Work Order ID 88696

Item Name: Crosstube Fwd

| A | NEW ISSUE | CP | 11.07.15 |
|------------|---|---|--------------|
| DE APPR. |  | SUPPORT INSTALLATION CHANGE | NTS |

| DRAWING NO. D206-667-143 | TITLE CROSSTUBE ASS'Y (206L HIGH FWD) | REV. C | DART AEROSPACE LTD ENGINEERING ORDER | | D.E.O. NO. D206-667-143-C-1 | SHEET NO. SHEET 1 OF 1 | SCALE NTS |

FIGURE 1 - GROUNDING STRAP INSTALLATION
(VIEW LOOKING FWD)

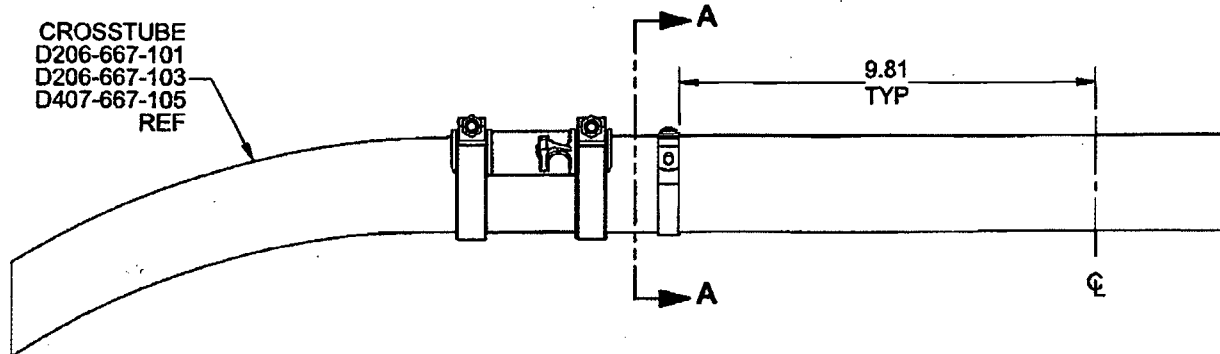
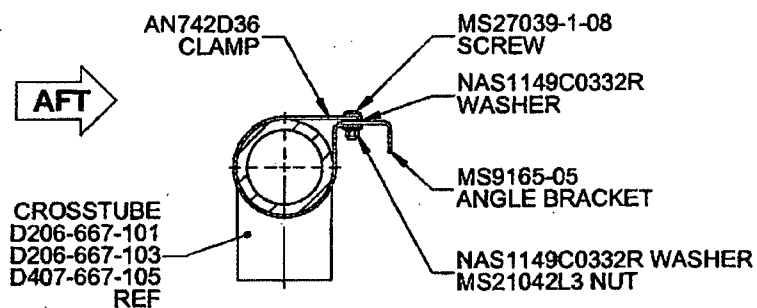
The purpose of this service instruction is to add the optional D206-667-017 Kit and provide guidelines to install extra clamps on D206-667-101/-103 or D407-667-105 forward crosstubes to allow fastening of OEM grounding straps.

- 1) If installed, follow Section 32.1 of ICA-D206-667 for removal of the forward crosstube from the helicopter.
- 2) Locate AN742D36 Clamp as shown in Figure 1 of this service instruction and mark location of clamp on the crosstube.

- 3) Remove crosstube finish (paint and primer) in area where AN742D36 Clamp will be installed and touch up affected area with chemical film material (Alodine 1200 or 1201) per MIL-C-5541.

- 4) Install AN742D36 Clamp complete with MS9165-05 per Section A-A of Figure 1 of this service instruction.
- 5) Touch up paint as required per Item 5.3.3 of ICA-D206-667.
